**Transbay Transit
Center Building
50% CD Overview**

January 2011

PARTIAL BUILDING SECTION @ GRIDLINE 23

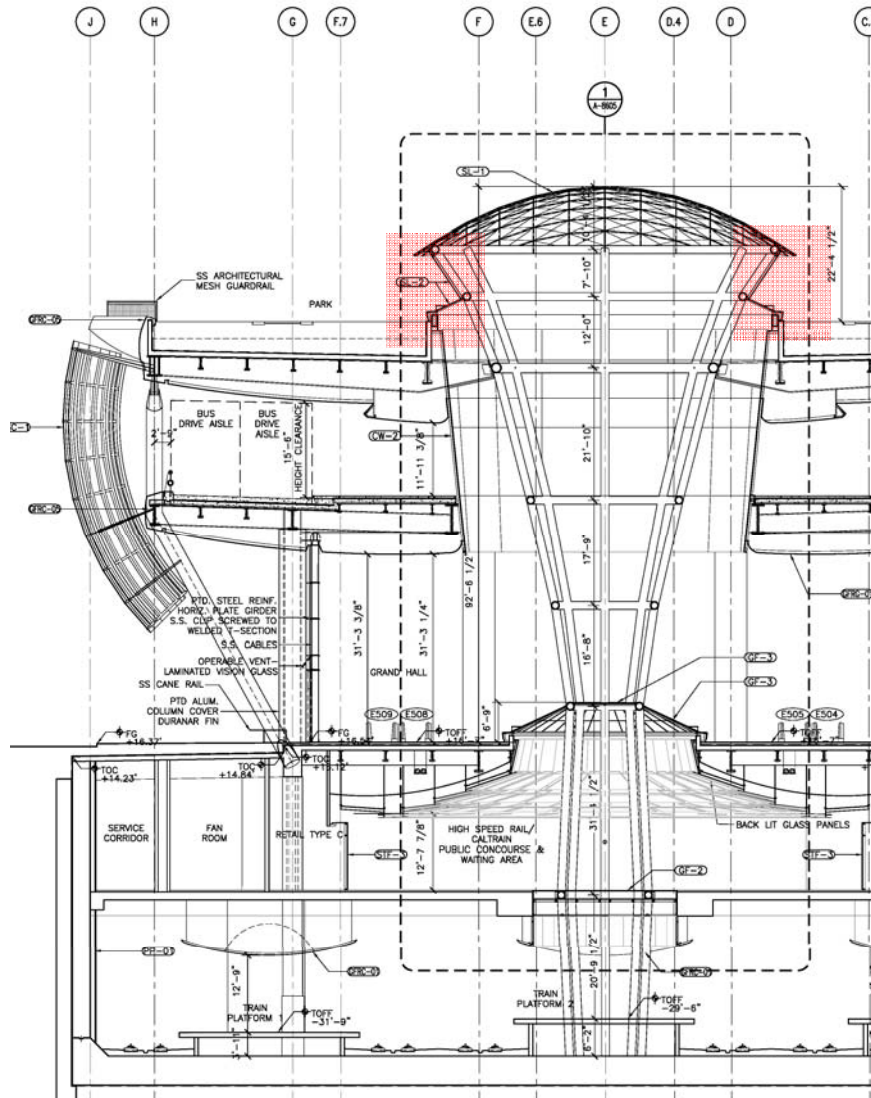
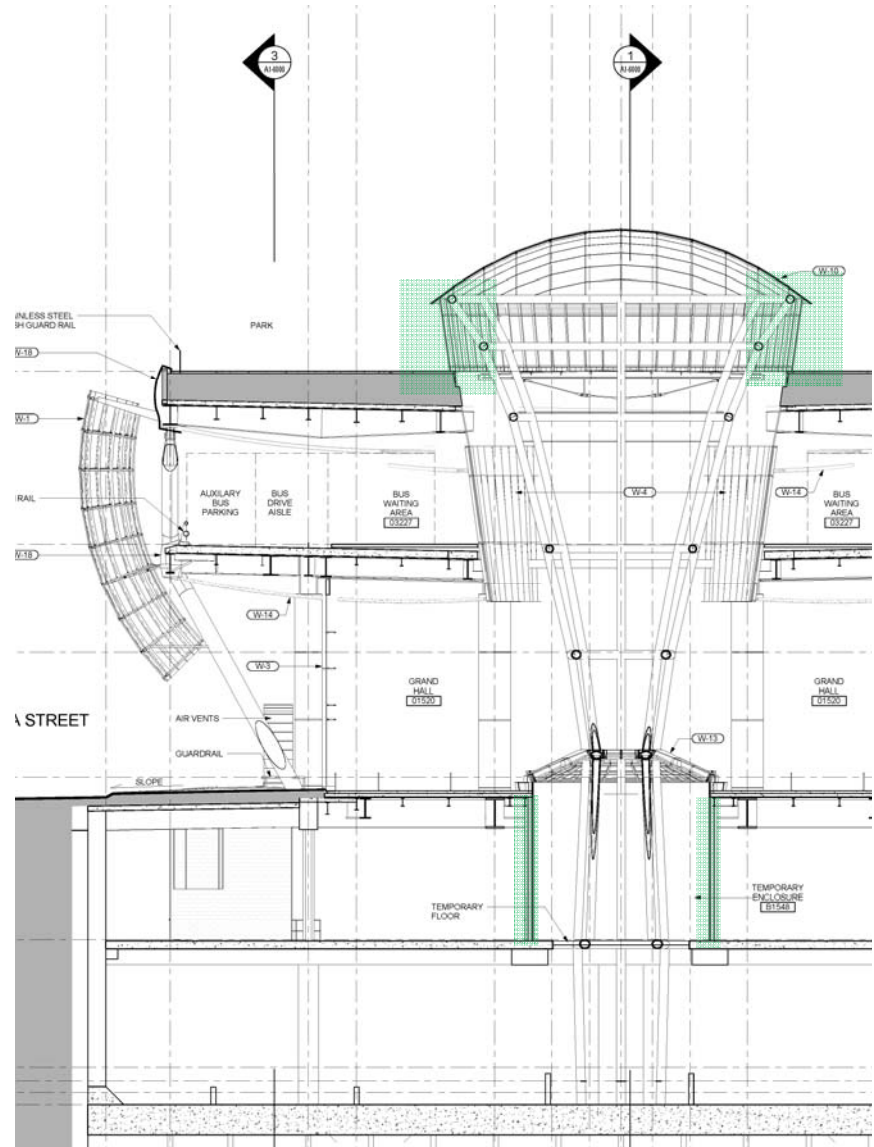
Cladding Systems Revisions Revised Awning geometry at Grid line 29 (W-1)

Cladding Systems Revisions

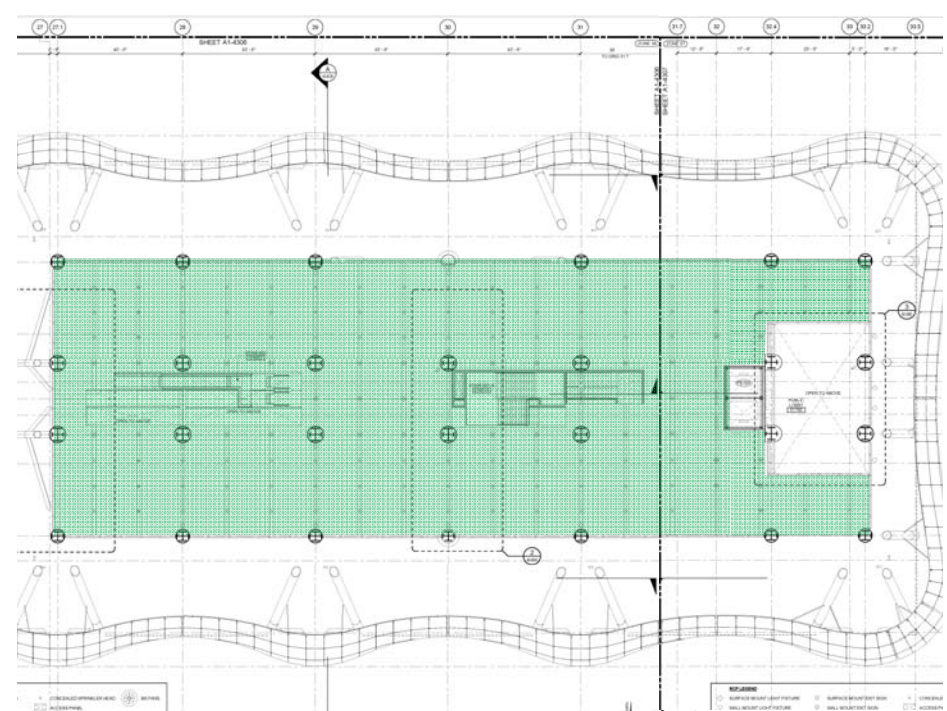
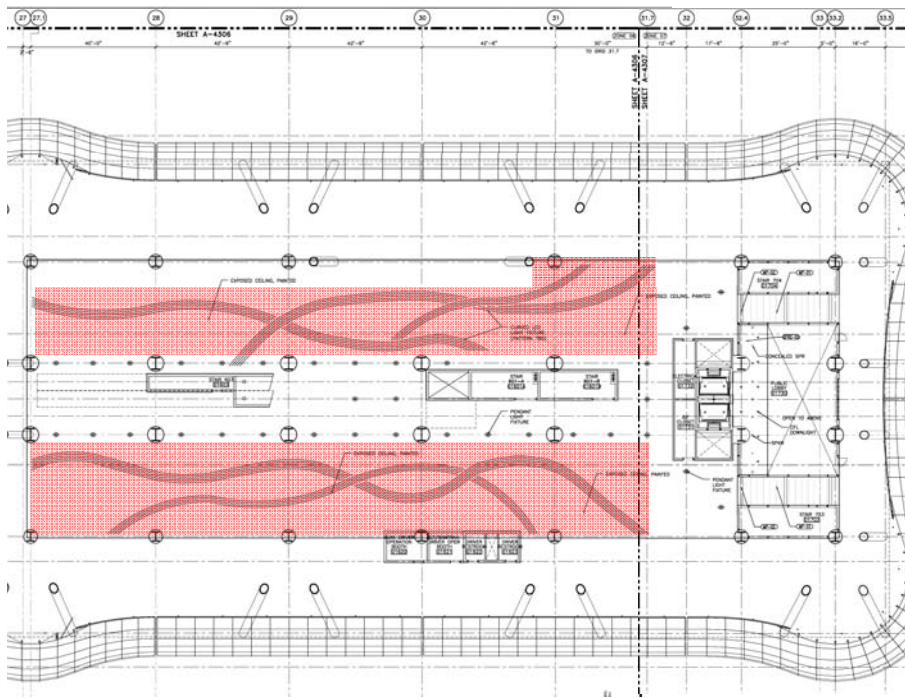
Revised Grand Hall east elevation from W-2 to W-3 system

WEST ELEVATION

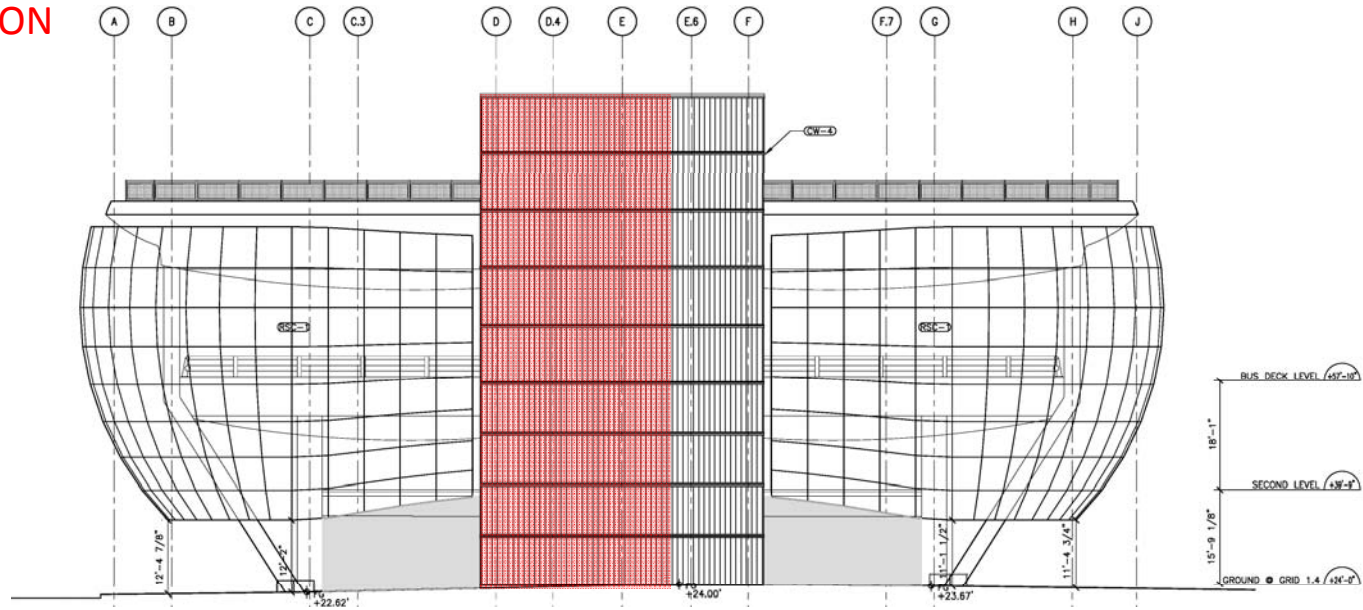
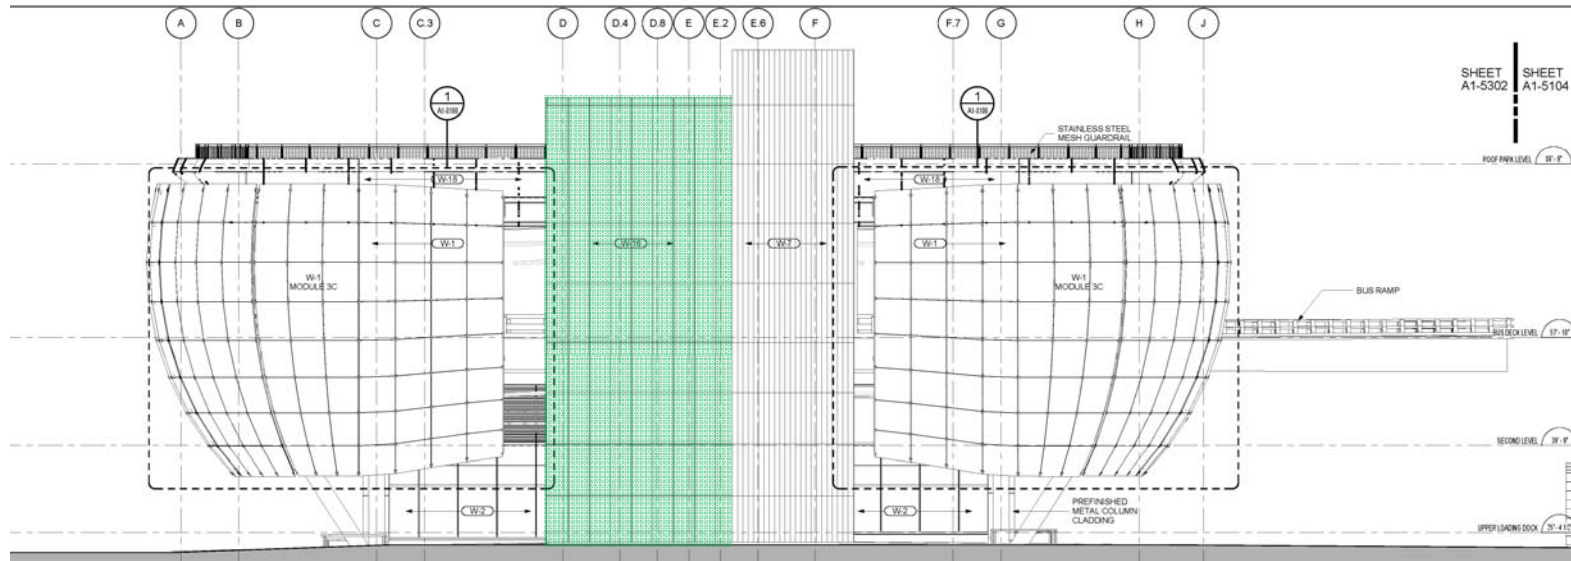
Cladding Systems Revisions – Stair 201
Replaced channel glass areas with metal panel (W-7 & W-16)
